JACK LONDON DISTRICT 4TH & MADISON PROJECT

Response to Comments Document

Case No. ER15-005

Prepared for:
City of Oakland

Figure VI-5
Jack London District 4th & Madison Project EIR
Proposed Project Aerial View

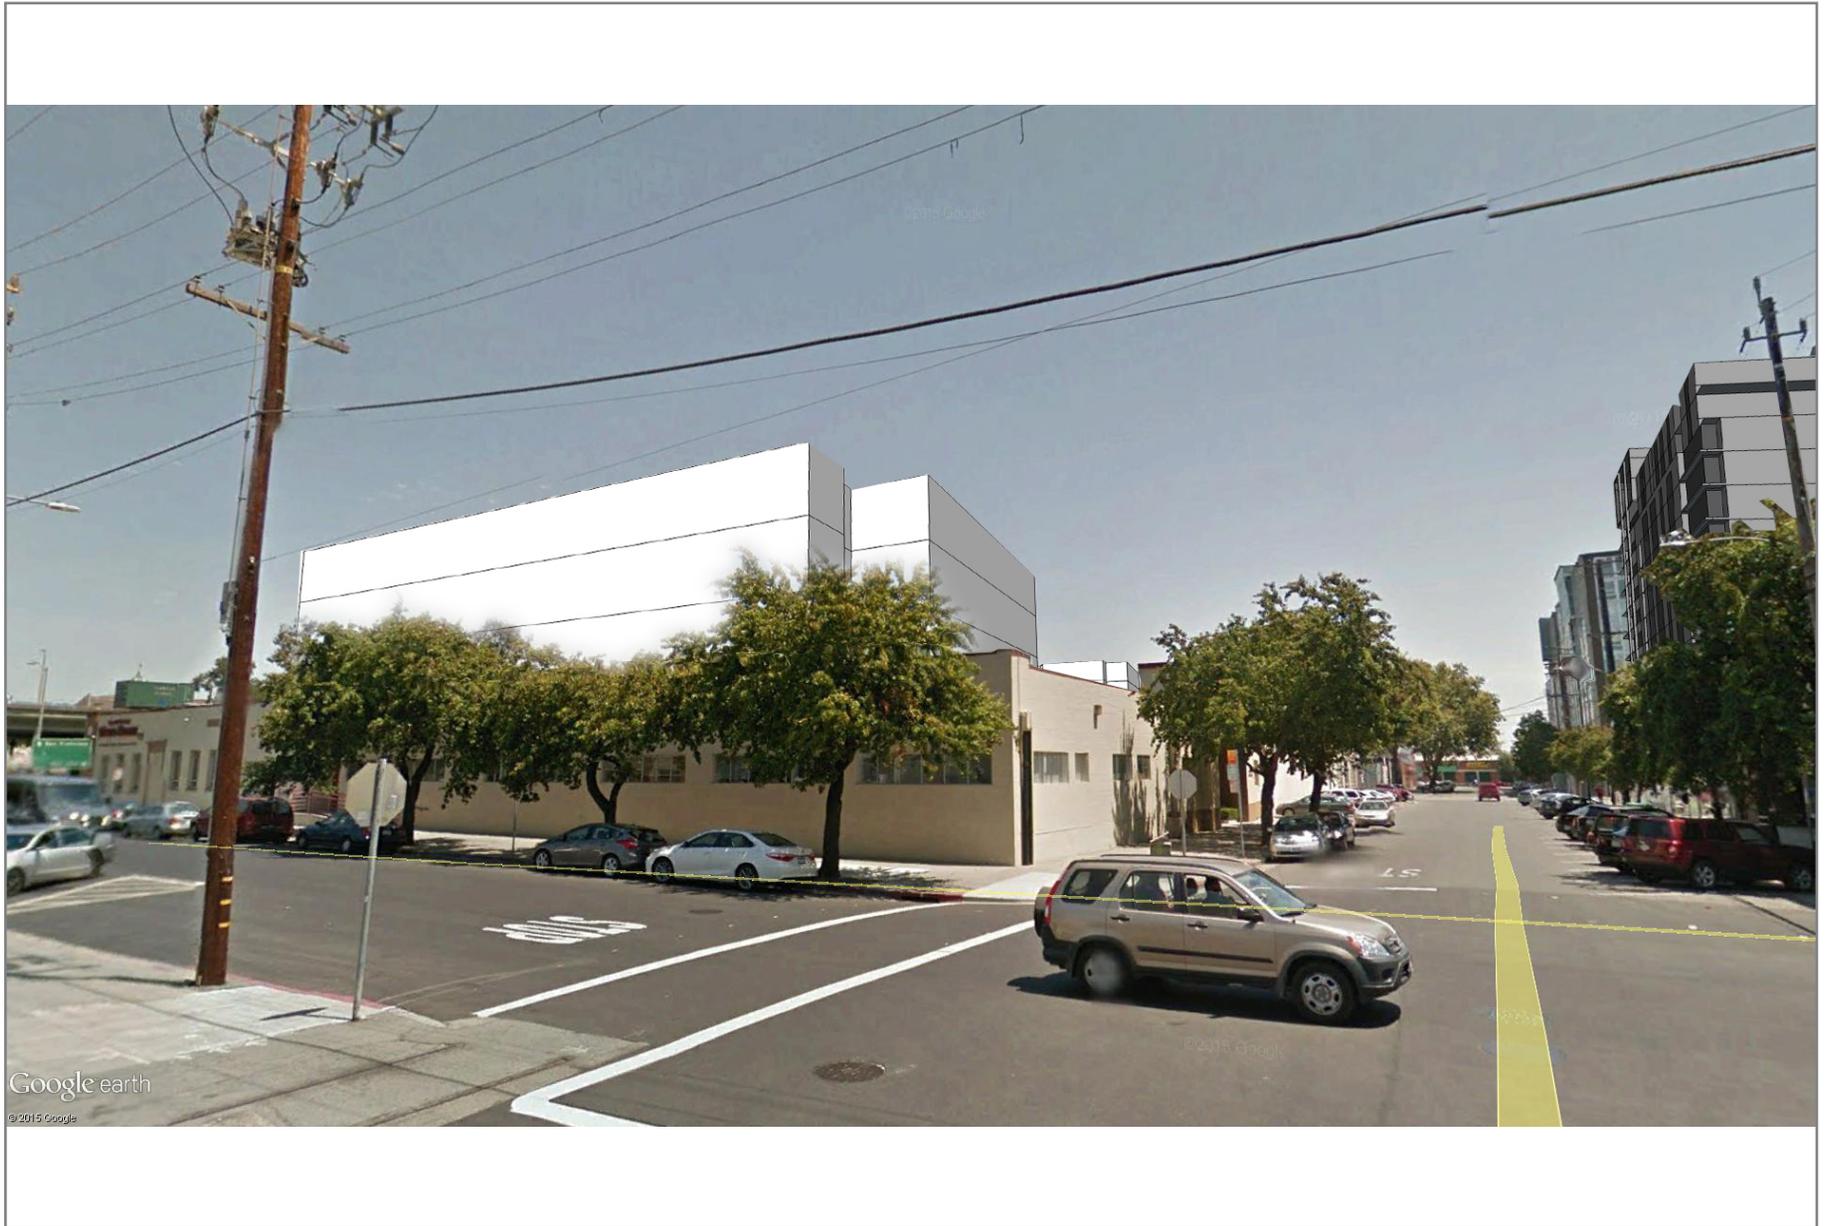
<ul style="list-style-type: none"> A Google earth aerial sketch showing proposed buildings in larger context is needed to assess impacts. 	Additional graphics—Figures VI-5 through VI-9—have been added to Chapter 6, Alternatives. Figure VI-5 specifically shows an aerial view of the proposed project design in the context of the surrounding existing buildings.
	<ul style="list-style-type: none"> If ground floor is parking, why not keep original façade? 	The project proposes demolition of the entire building, but please see Chapter VI of the EIR which evaluates two alternatives to the project, each of which preserve portions of the Building A façade to varying degrees.
	<ul style="list-style-type: none"> Appreciates the opportunity to comment. 	Comment noted. No further response is necessary.
D5 Stafford Buckley		
	<ul style="list-style-type: none"> People are drawn to the WWD; concerned that this project will decrease what attracts them. 	This comment does not specifically address the adequacy of the EIR. It has been noted, but no further response is necessary.
